Application of Safe Haven Transitional, Inc. c/o Battle Law, P.C. for a Special Land Use Permit (SLUP) to allow an office building in Tier 5 Corridor 1 of the Bouldercrest Overlay District and the C-1 (Local Commercial) zoning district, at 2001 River Road.

PETITION NO: N7-2026-1266 SLUP-26-1248280

STAFF ANALYSIS

CASE NO.:	SLUP-26-1248280	File ID # 2026-1266
Address:	2001 River Road, Ellenwood, Georgia 30294	Commission Districts: 3 & 6
Parcel ID(s):	15 053 03 001	
Request:	Application of Safe Haven Transitional, Inc. c/o Battle Law PC for a Special Land Use Permit (SLUP) to allow an office building in the C-1 (Local Commercial) zoning district and Tier 5 Corridor 1 of the Bouldercrest Overlay District.	
Property Owner(s):	Safe Haven Transitional, Inc.	
Applicant/Agent:	Safe Haven Transitional, Inc c/o Battle Law, PC.	
Acreage:	0.59	
Existing Land Use:	Vacant land	
Surrounding Properties:	North: A vacant building previously used as a grocery; South: Single-Family home East: Single-Family home West: Single-family home, vacant land, and place of worship (Kingdom Ministries).	
Adjacent Zoning:	North: Tier 5 Corridor 1/C-1; South: Tier 5 Corridor 1/R-100; East: Tier 5 Corridor 1/R-100

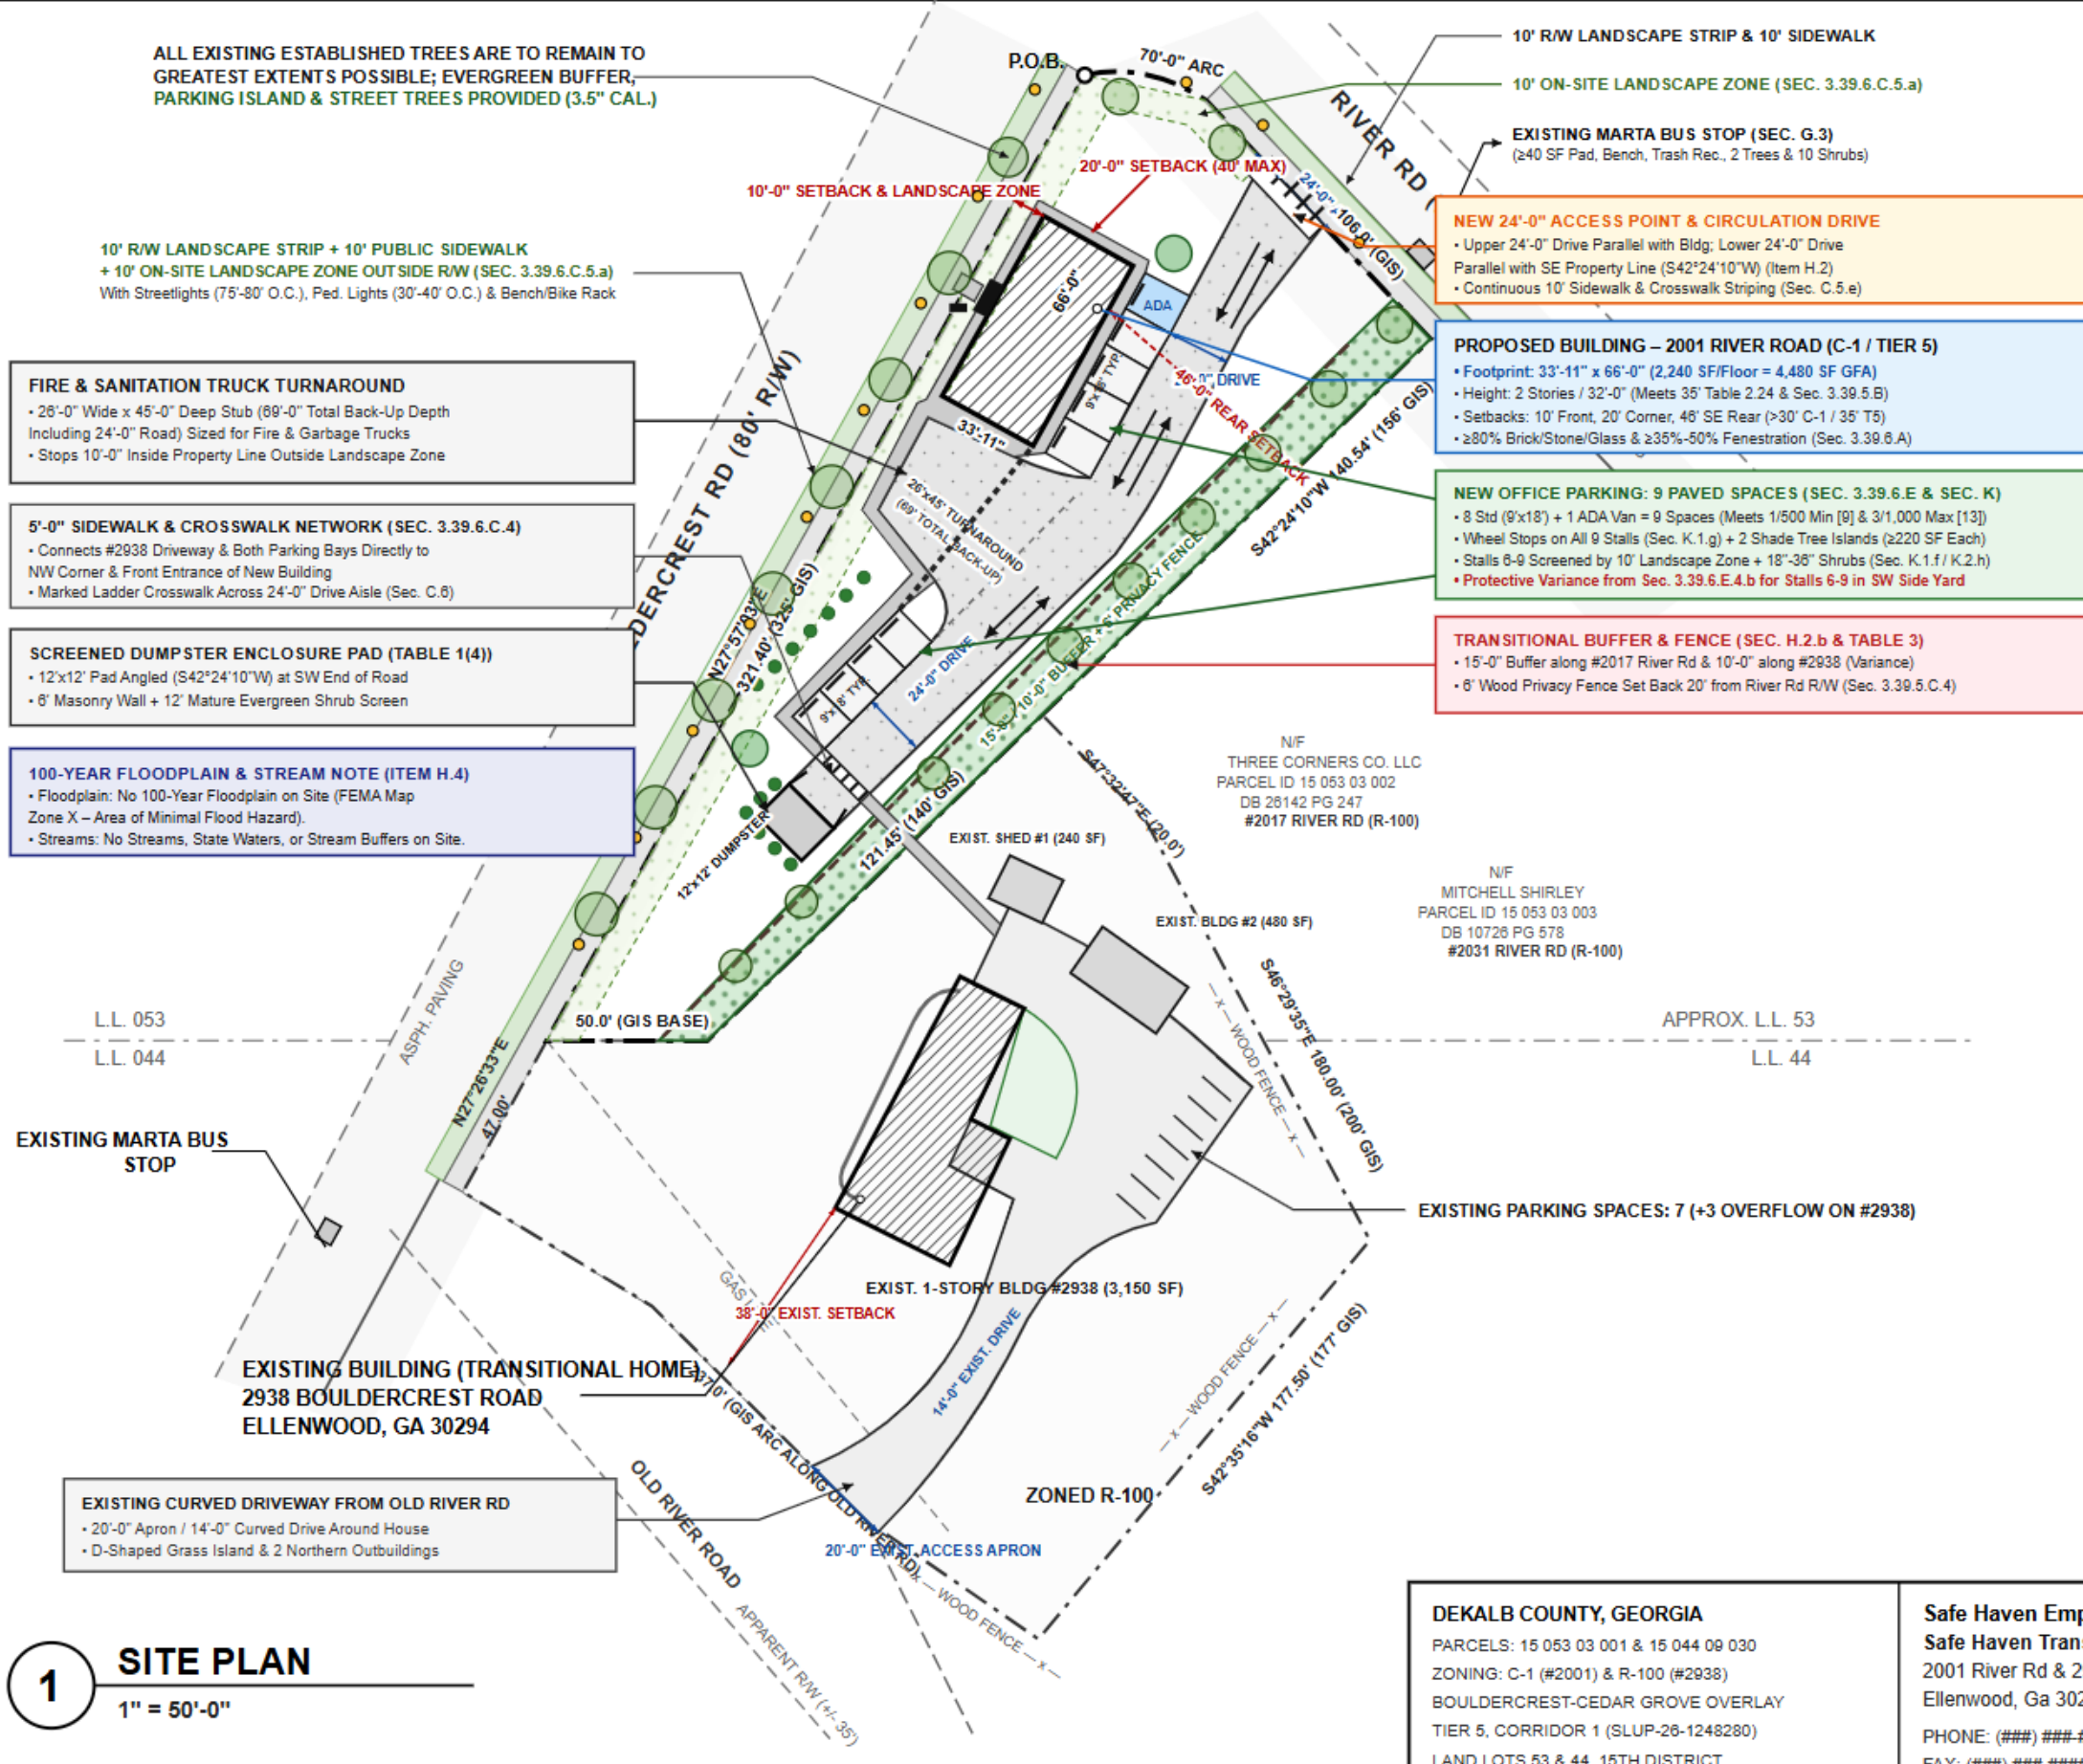
The SLUP application shows compliance with most of the BOD Tier 5 office criteria, including “Section 3 Criteria A through C” (Eligibility and Access Requirements), and “Section 4 Criteria A through D and F through I” (Additional Tier V Office Supplemental Regulations). However, the conceptual plan does not comply with “Section 4, Criteria “E” which requires a 30- foot buffer along the rear property line abutting an underlying R-100 zoned residential property and the submitted plan only shows a 15-foot-wide buffer.

- E. **Transitional Buffer.** A transitional buffer of not less than 30 feet in width shall be provided and maintained with vegetation that adequately screens buildings viewed at eye level from adjacent underlying "R" zoned properties. **The plan is not in compliance since the proposed buffer is only 15 feet.**

Based on the submitted information, and field investigation of the project site, the Subject Property comprises approximately 0.59 acre and is currently vacant. Section 4, Criteria “E” states that a transitional buffer of not less than 30 feet in width shall be provided and maintained with vegetation that adequately screens buildings viewed at eye level from adjacent underlying “R” zoned properties”. The submitted plan does not comply since the proposed buffer shown along the rear property line which abuts an underlying “R” zoned property is only 15 feet. Therefore, the site might not be adequate for the use contemplated. The Applicant indicates that there will be adequate refuse collection and service areas in compliance with applicable codes, and that service areas will be screened from view consistent with Tier 5 design guidelines. The proposed two-story office building is consistent with the one and two-story building heights in the surrounding area. It appears that the size, scale, and massing is appropriate.

Therefore, **based on review of Section 4 Criteria “E” of the Tier 5 office criteria (Transitional Buffer), Section 27-7.4.6 A (Adequacy of the site), and B (Compatibility), and, it is the recommendation of the Planning & Sustainability Department that the applicant be, respectfully, “Denied”.**
